Report to Development Permit Panel

File: DP 20-890821

Re: Application by Systemos Development Ltd. (Paramjit Kahlon) for a
General Compliance Ruling at 5500, 5502, 5506 and 5508 Williams Road
(formerly 5500 Williams Road)

ATTACHMENT 2: TREE MANAGEMENT PLAN (DP 20-890821)

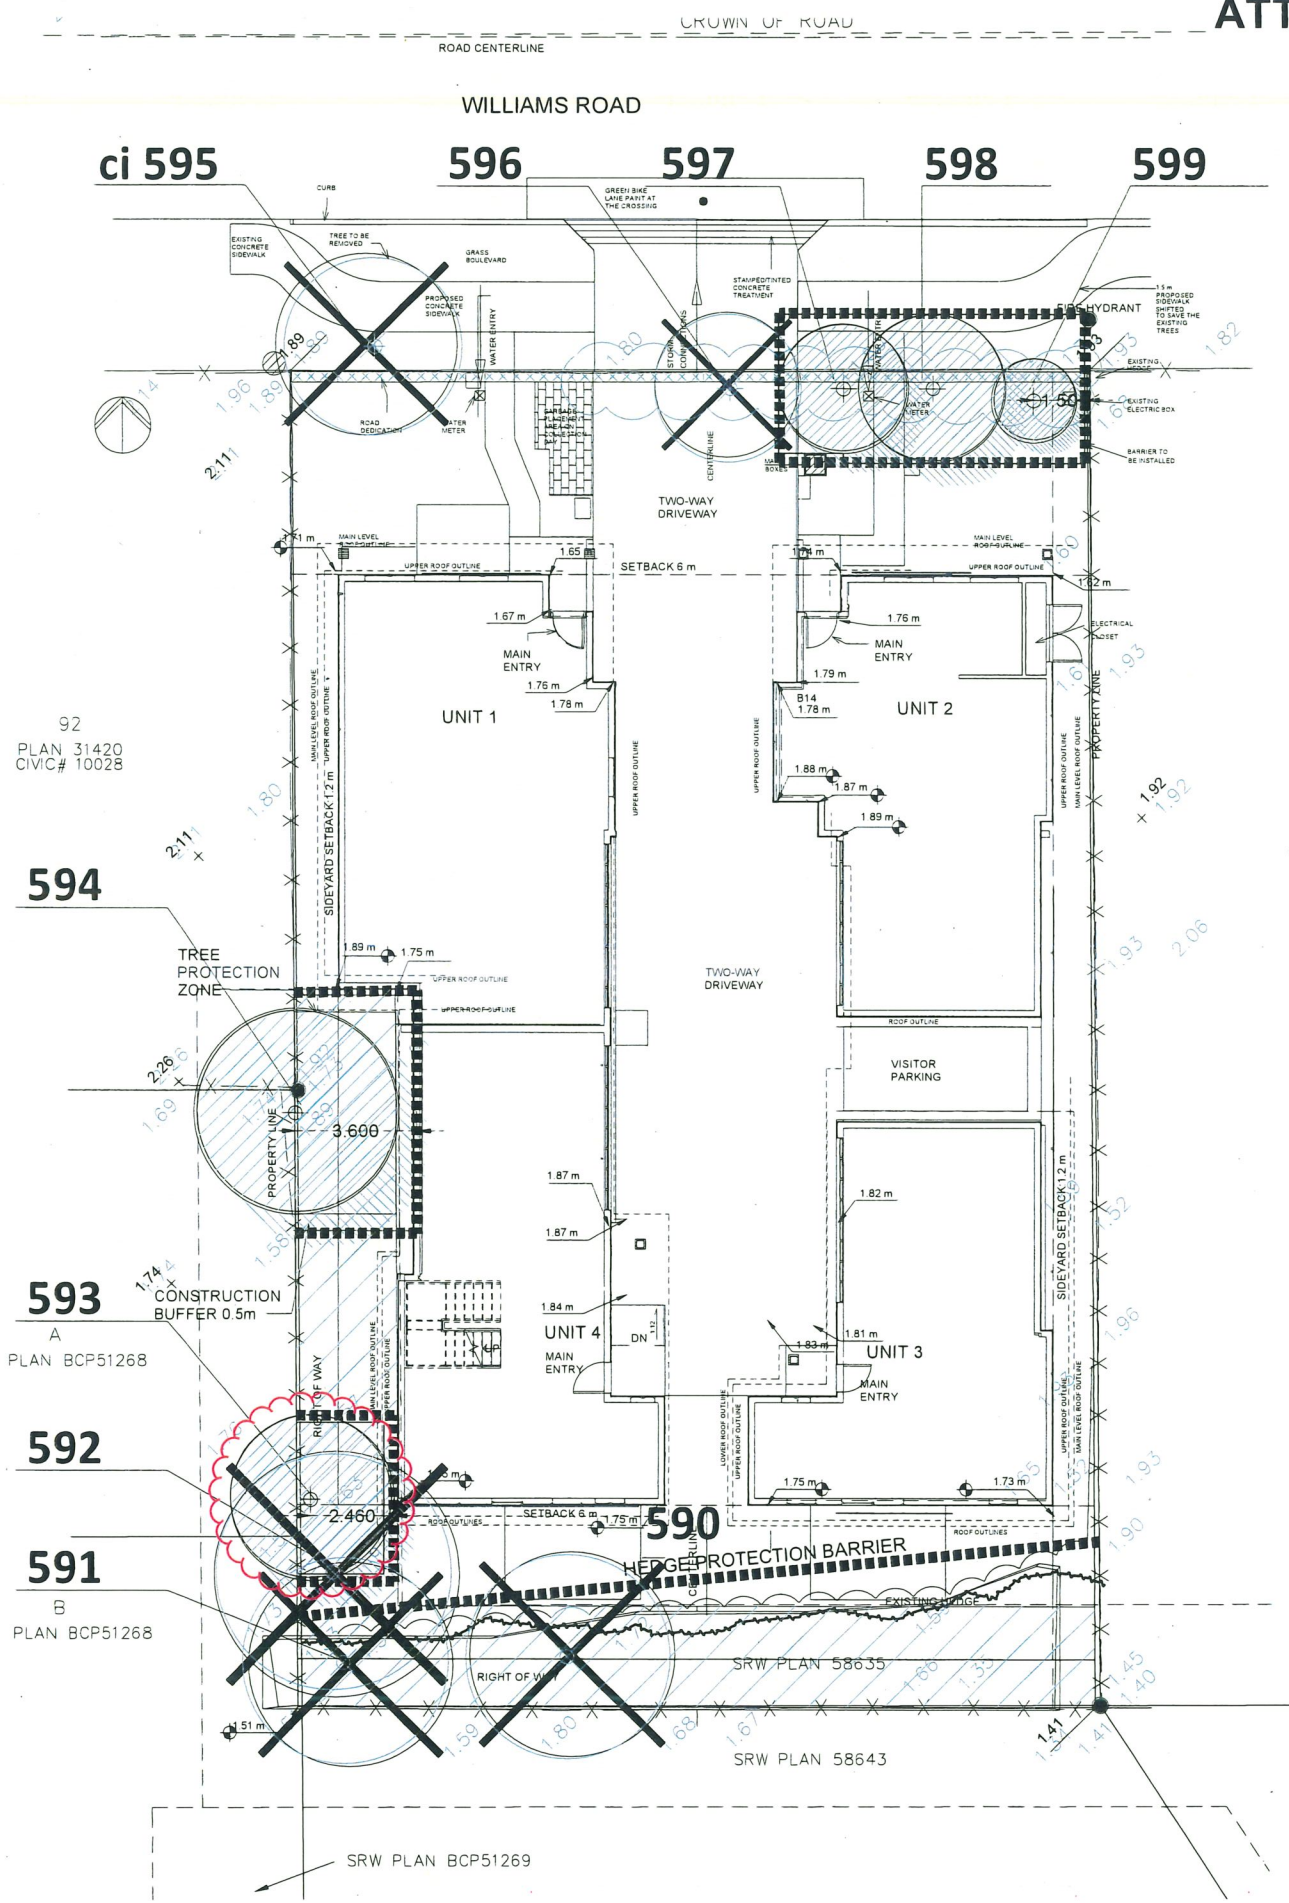
- During demolition, a plum tree (tag #593) was damaged and subsequently removed during the demolition of an on-site garage in its proximity. This plum tree (tag #593) to be retained in the west side yard of Lot A (5500/5502 Williams Road), was removed contrary to the issued Development Permit (identified in a red bubble in Attachments 2 and 3). The project arborist advised the City of the situation following the removal of the tree.

ATTACHMENT 4: PROPOSED TREE MANAGEMENT PLAN

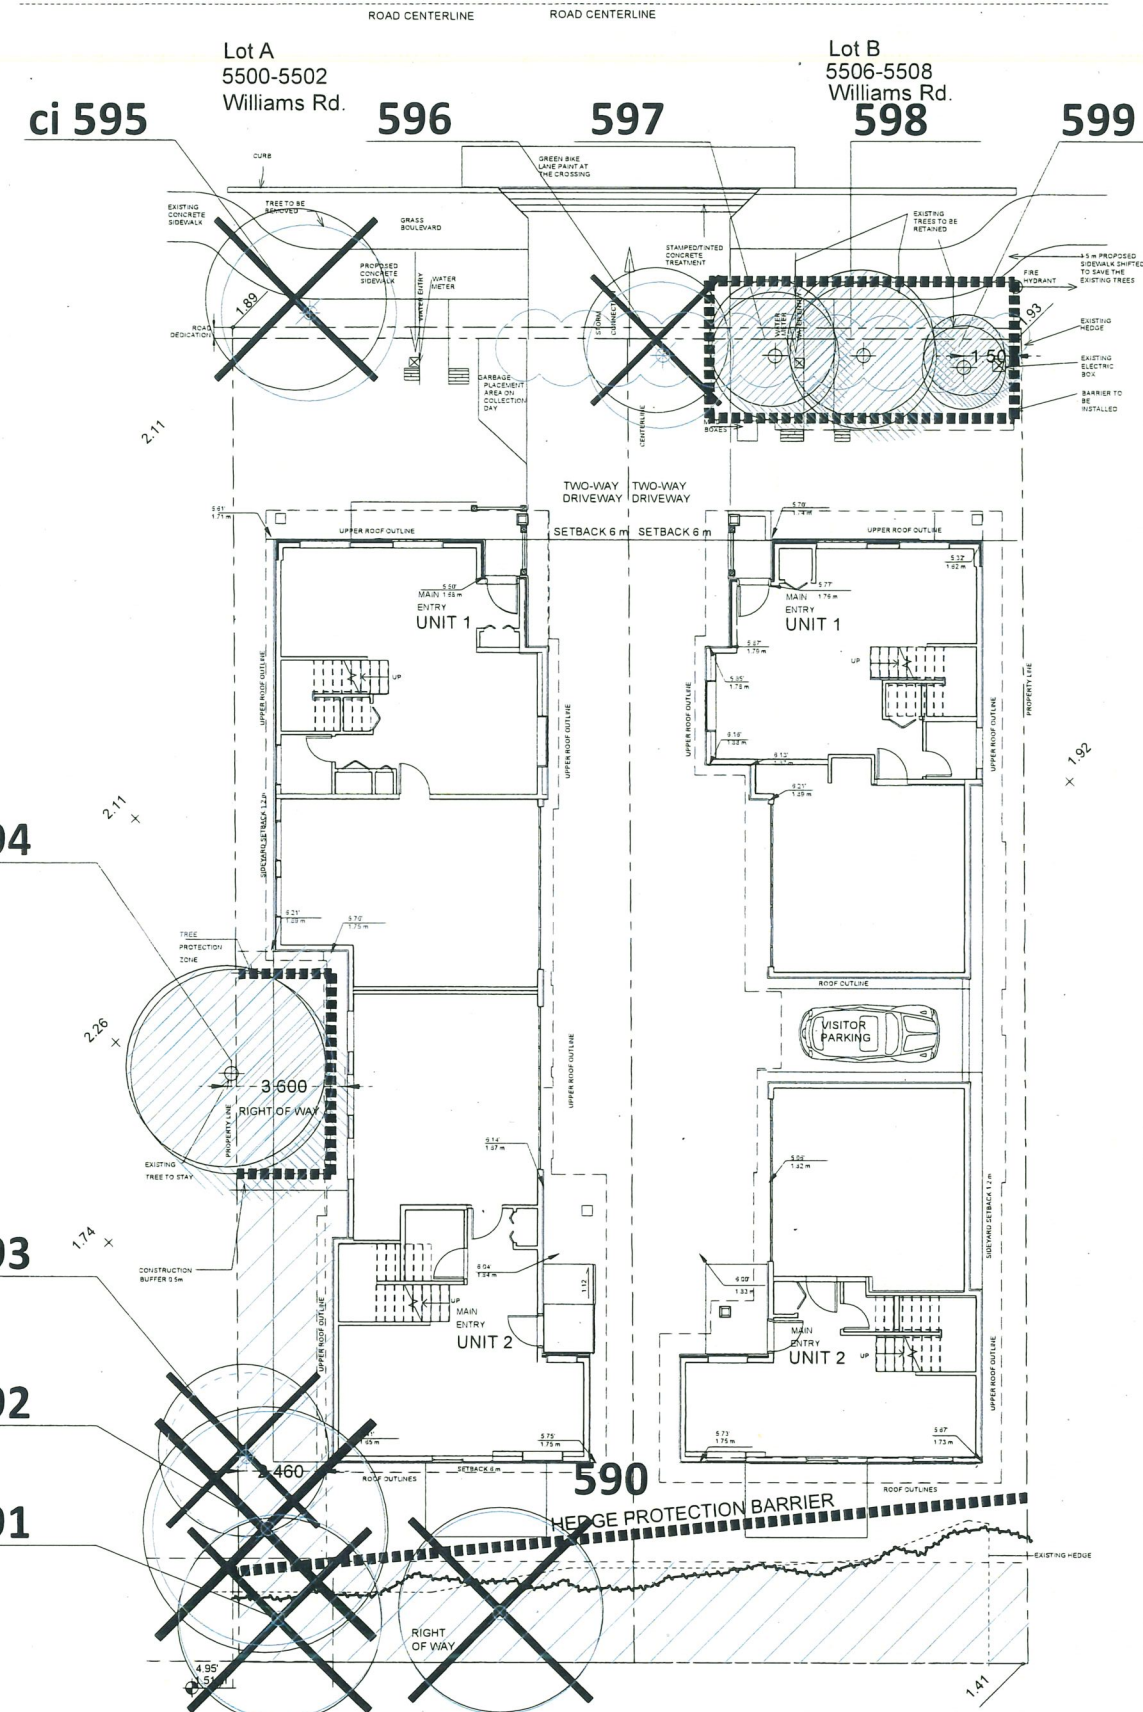
This General Compliance application is for a modification to the issued Development Permit (DP 20-890821) to address the unauthorized removal of a tree that was to be retained. The proposed modification includes changes to the Tree Management Plan and Landscape Plan issued with the Development Permit (DP 20-890821). A Servicing Agreement (SA 20-907102) has been entered into and the final design of the off-site works is currently under review. The proposed changes to the Tree Management Plan and Landscape Plan do not impact any works associated with the Servicing Agreement.

- To account for the unauthorized removal of the plum tree (tag #593), the applicant proposes to:
 - Maintain the modified building setback established to retain the tree which was removed.
 - Plant one large replacement tree (10.0 cm caliper Quercus Robur Crimson Spire) in the south-west corner of Lot A (5500/5502 Williams Road), as shown in the revised Tree Management Plan and Landscape Plan (Attachments 4 and 5). The replacement tree is to be planted slightly south of the location of the original tree, and away from the proposed building to provide sufficient space for its growth.
 - Increase the size of all other required replacement trees to be planted on Lots A and B as indicated in the following table.
